South Shaganappi Study Design Ideas Workshop & CAG Meeting #2

Stakeholder Report Back: What we Heard
May 9, 2016

Design Ideas Workshop

Map 2P

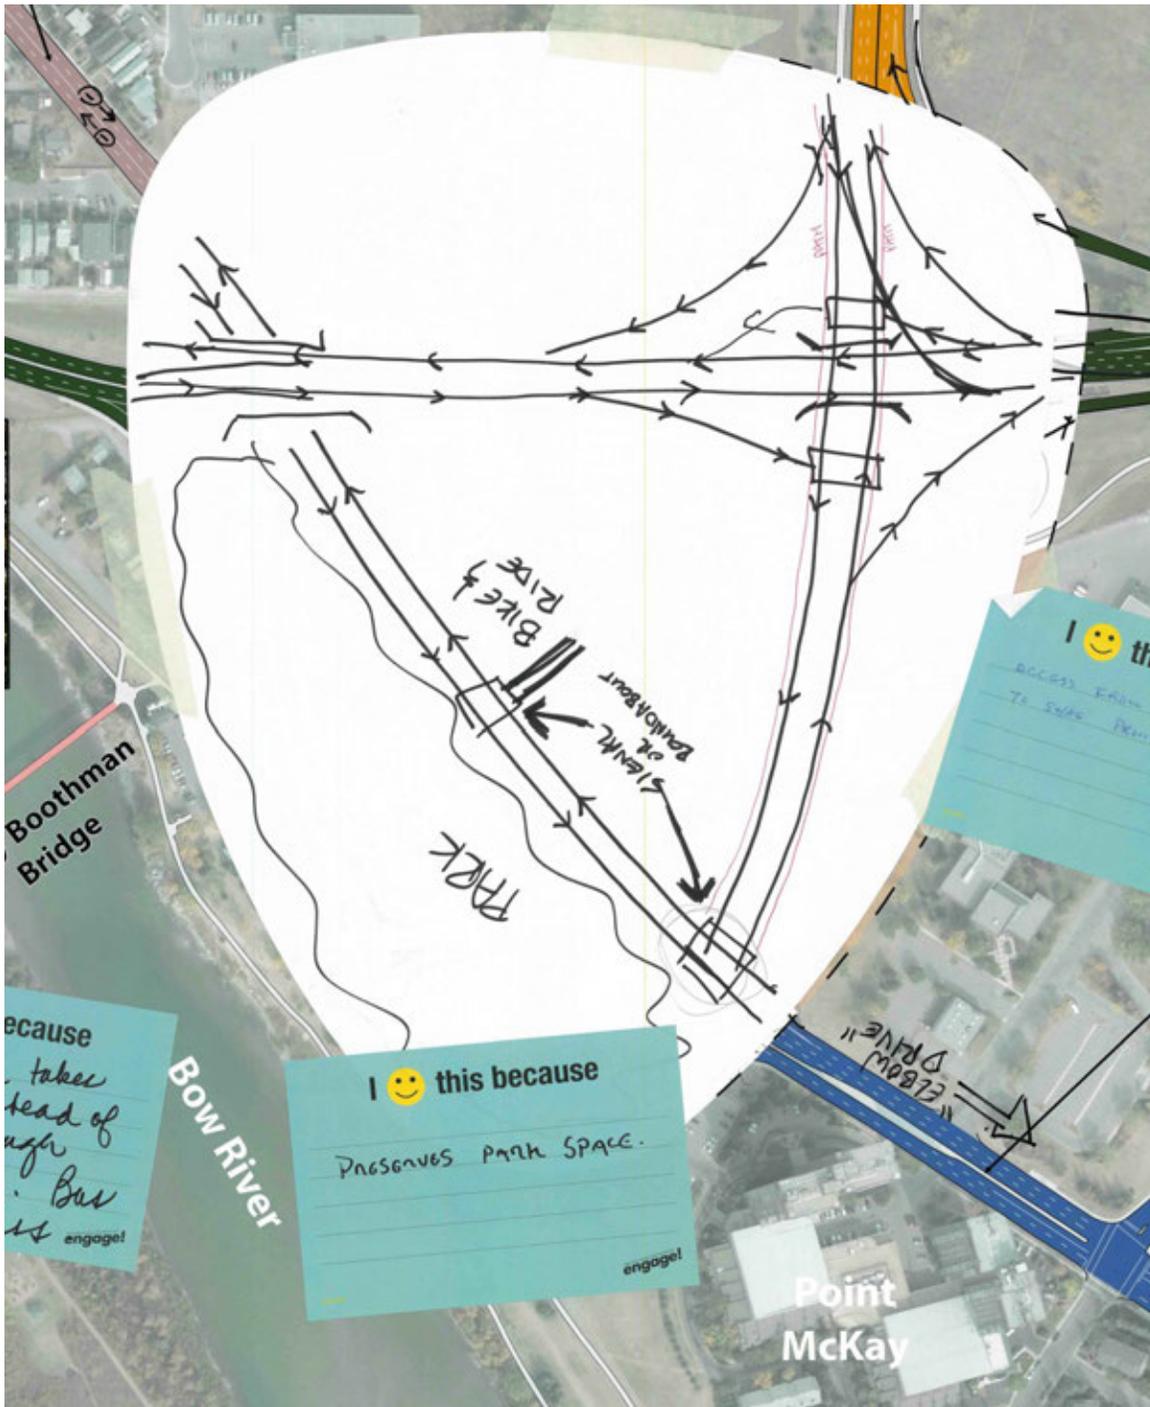
- Explore the option of maintaining more park space closer to the river
- Fewer traffic signals
- Fix access from eastbound 16th Avenue N.W. to southbound Shaganappi Trail

- Discussion on pros and cons of cloverleaves: why not full cloverleaves?
 - o Space issues
 - o Pedestrian/cycle concerns
 - o Cost
- Traffic calming on Bowness Road near Shaganappi Trail

- Bowness Road is an important bike connection
- How do we integrate bikes and pedestrians in a seamless way?
- Free flow movement from Shaganappi Trail to eastbound 16th Avenue N.W. to connect to better downtown routes than Parkdale Boulevard

- Fast/free flow traffic on 16th Avenue N.W. . important
- Addition of good use of multi-use paths
- Connect Bowness Road through Shaganappi Trail to optimize green space

- Want Bowness Road to be more like Elbow Drive
- Improve Bowness Road for pedestrian and cycle usage
- Use the land for green space, commercial, residential etc. just not roads

- Do not add traffic on Parkdale Boulevard
- Use roundabouts on Bowness Road

- Concerned that pressure on roads will increase
- Need better sidewalks
- Bike lanes on Bowness Road west of 16th Avenue N.W.

- It fixes connection issues at 16th Avenue N.W. and Shaganappi Trail and calms Bowness Road
- Increases parking and park space
- Emphasize 16th Avenue N.W. and Shaganappi Trail as main artery

- Turns Bowness Road into community connector
- Allows Bowness Road to Parkdale to be pedestrian/bike friendly and human-scaled for residents
- Emphasizes traffic flow - Shaganappi to 16th Avenue N.W. Deemphasizes traffic flow onto Bowness Road

- Like bike path access to help increase use/safety to park
- Considers transportation other than single driver in a car
- Considers welfare of surrounding community residents

- The concern for pedestrians/bike safety as a priority
- Focus of Shaganappi Trail and 16th Avenue N.W.
- Access from 16th Avenue N.W. to eastbound to Shaganappi Trail provided

- Southbound takes 16th Avenue N.W. instead of driving through Parkdale. Bus still has access
- Preserves park space

Map 3P

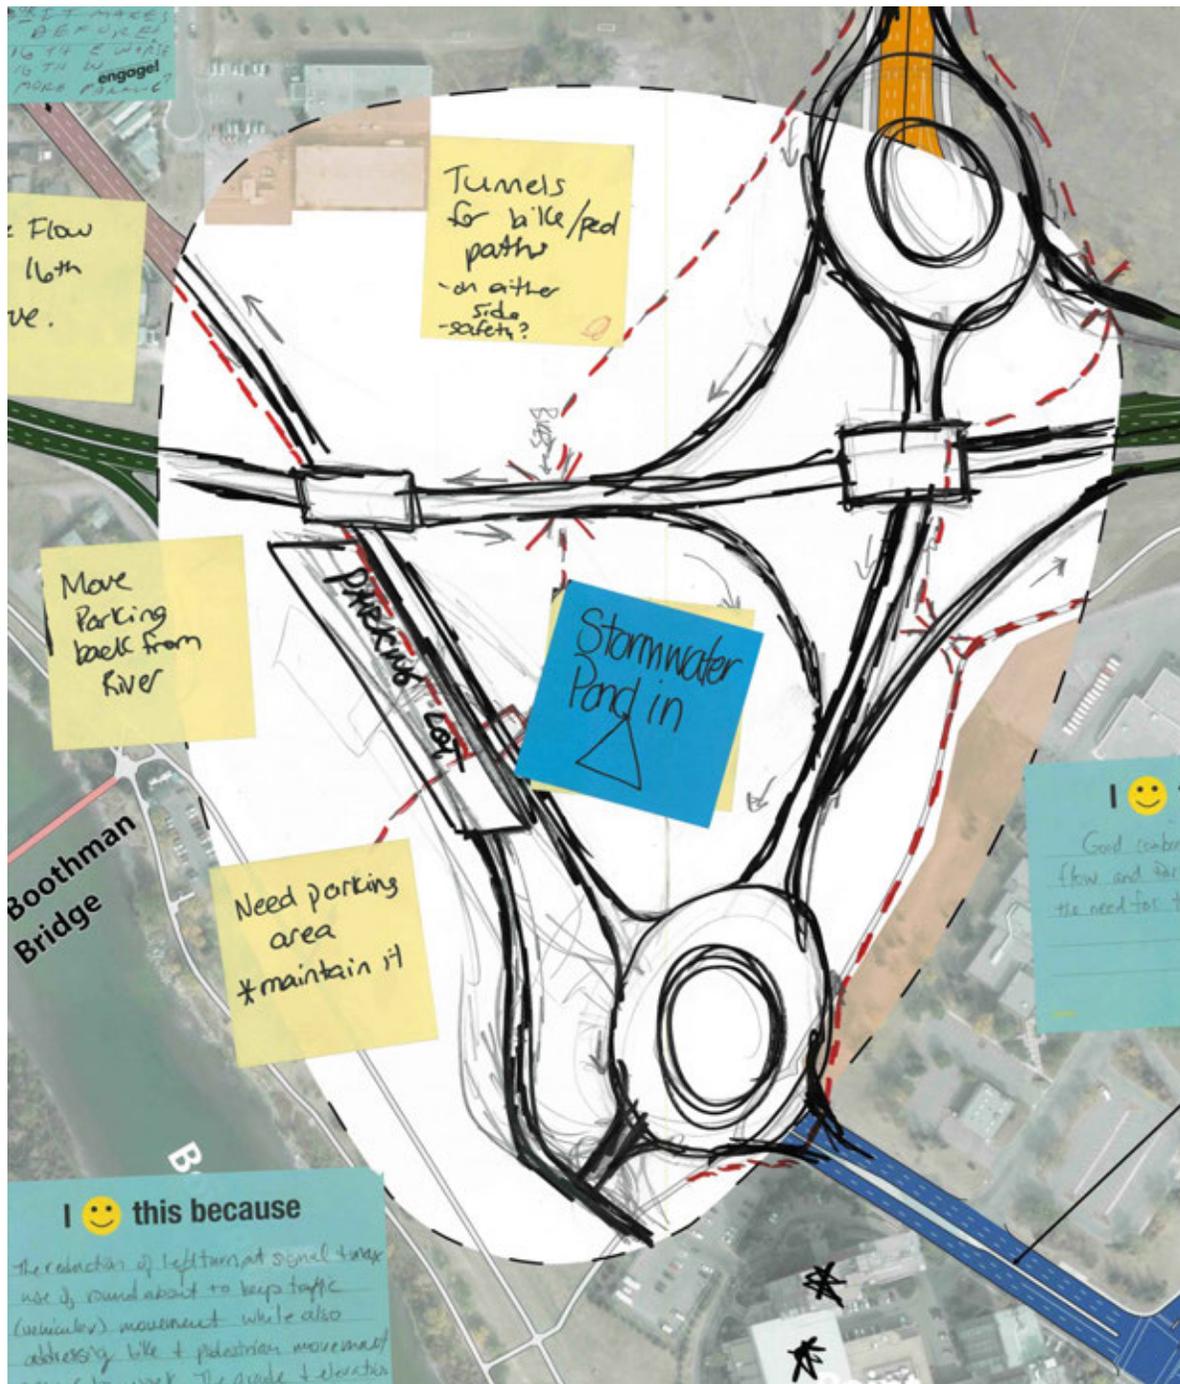
- Safety concerns at Shaganappi Trail and Bowness Road
- Re-designate 16th Avenue N.W. as no heavy goods (because of Ring Road)
- Reduce speed changes along Bowness Road (more consistent)

- Lights on Bowness Road should have sensors (not timers)
- Shouldn't reroute onto 16th Avenue N.W. exclusively because there's no way to get off
- Additional intersections and development on north leg of Shaganappi Trail are going to increase traffic

- Maintain free flow on 16th Avenue N.W. – should be main route east
- Left turn on Home Road for Montgomery residents
- No left turns; traffic circles
- System should allow for access to all roads (with no left turns)

- Circles work!
- Will need to be well signed
- Will be confusing at first
- Constraint: Shaganappi Trail to 16th Avenue N.W. access is longer but no stopping

- Eliminate lights
- Extra space should be green and support bikes and pedestrians
- Include stormwater pond – ties to City of Calgary water quality plans

- I love the storm pond!
- This has no left turns and got rid of a light and did not add any. This makes everything better OR it makes an "equal to before" eg. Shaganappi Trail south to 16th Avenue N.W. east worse but Shaganappi south to 16th Avenue N.W. west a lot better.

- Use of roundabouts
- The reduction of left turn at signal and max use of roundabout to keep traffic (vehicular) movement while also addressing bike and pedestrian movement appears to work. The grade and elevation of through fares should be considered
- Good combination of traffic flow and park space. Eliminates the need for traffic lights
- This is the best plan because traffic will move
- No left turns x 3

Map 4P

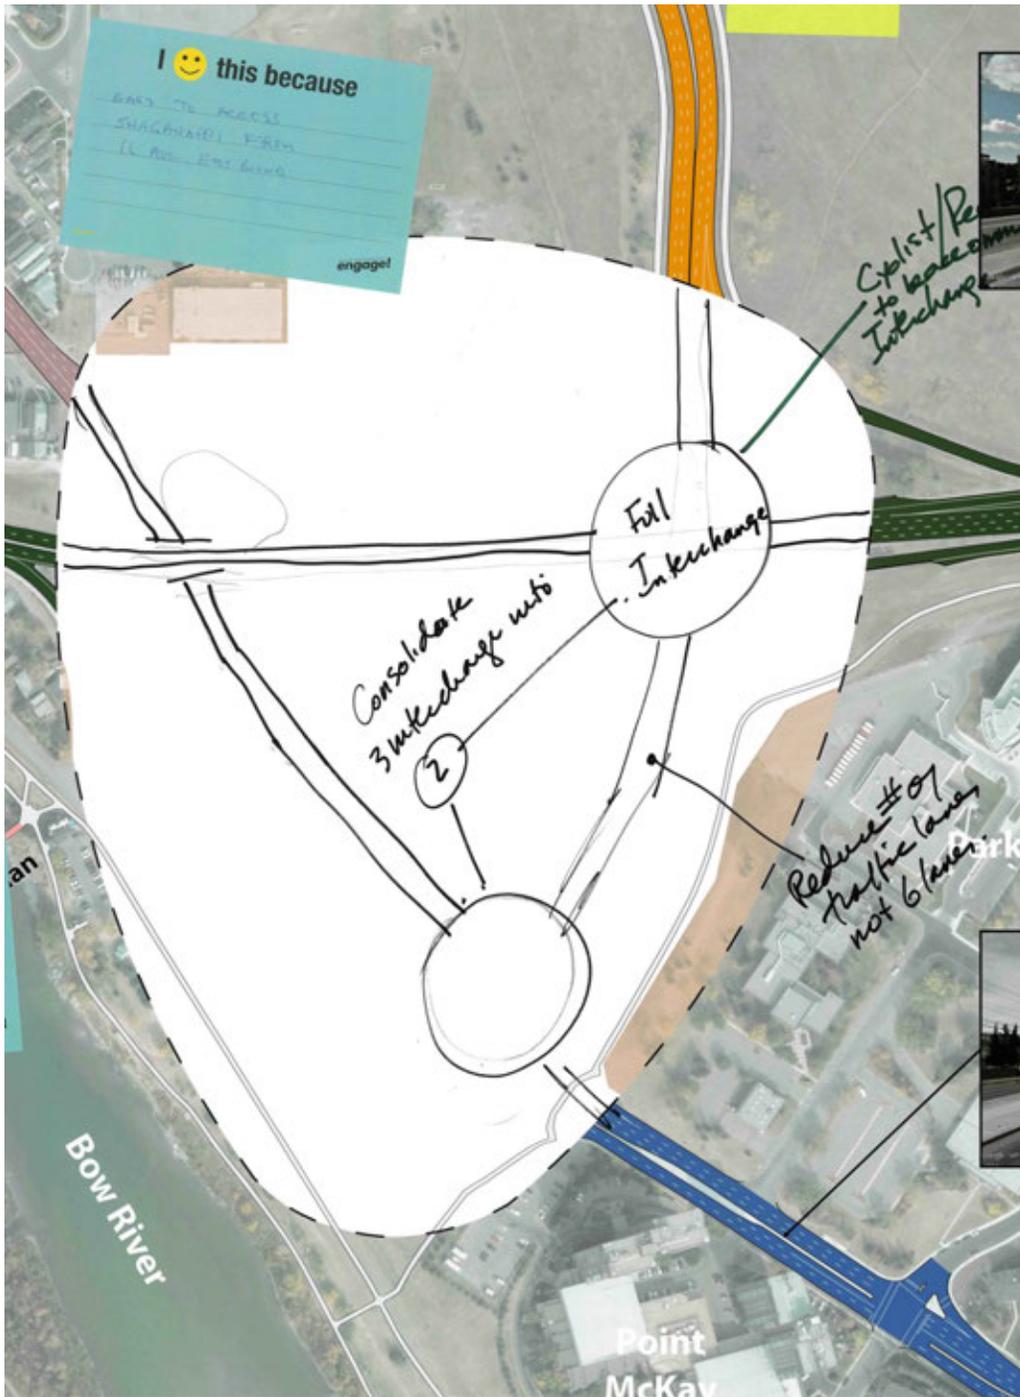
- Can we simplify or focus the traffic movements so we can remove spread out traffic lanes that seem inefficient?
- Off of 16th Avenue N.W. on to Shaganappi Trail without shortcuts through the community
- Intersection at Bowness Road a dangerous point for pedestrians
- Major pedestrian corridor
- Pedestrian and cyclists need to be incorporated into the interchange
- More efficient flow without upstream community short-cutting
- There is an east-west problem if you funnel people to 16th Avenue N.W without easterly access to downtown no one will take it
- 16th Avenue N.W. widened out so traffic coming into dedicated lane not a yield
- Allow for easy N-S and E-W movements with full pathway

Map 5P

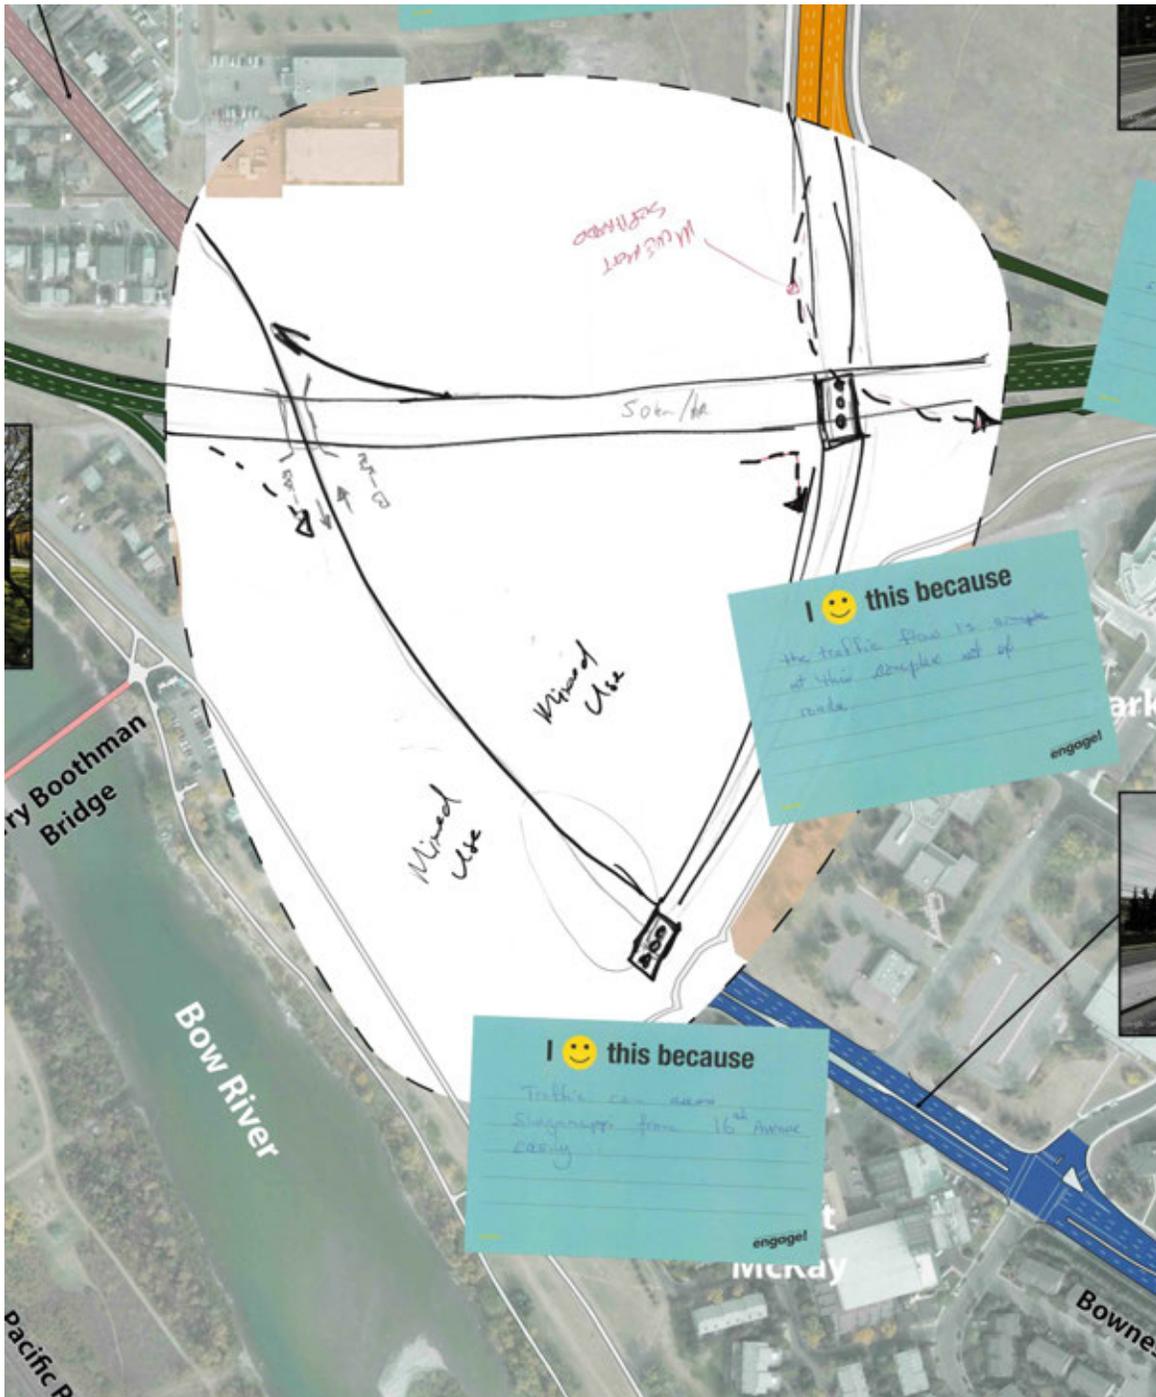
- Question: is the intent to keep people off of Bowness Road? Yes for some
- Several developments will feed traffic increase
- A lot of back-up getting on to 16th Avenue N.W.

- Bus – route to Northland Mall – meanders
- Question: what are the traffic patterns? Stats?
- Move people – car bus, bike, walk
- Park – gorgeous – need to ensure good access

- o Inefficient land use
 - o Inefficient east direction traffic flow (Bowness Road)
 - o 7 minute drive = 1 hour bus
- Opportunity/solution
 - o Remove vehicles from Bowness Road east of Shaganappi Trail (bikes only)
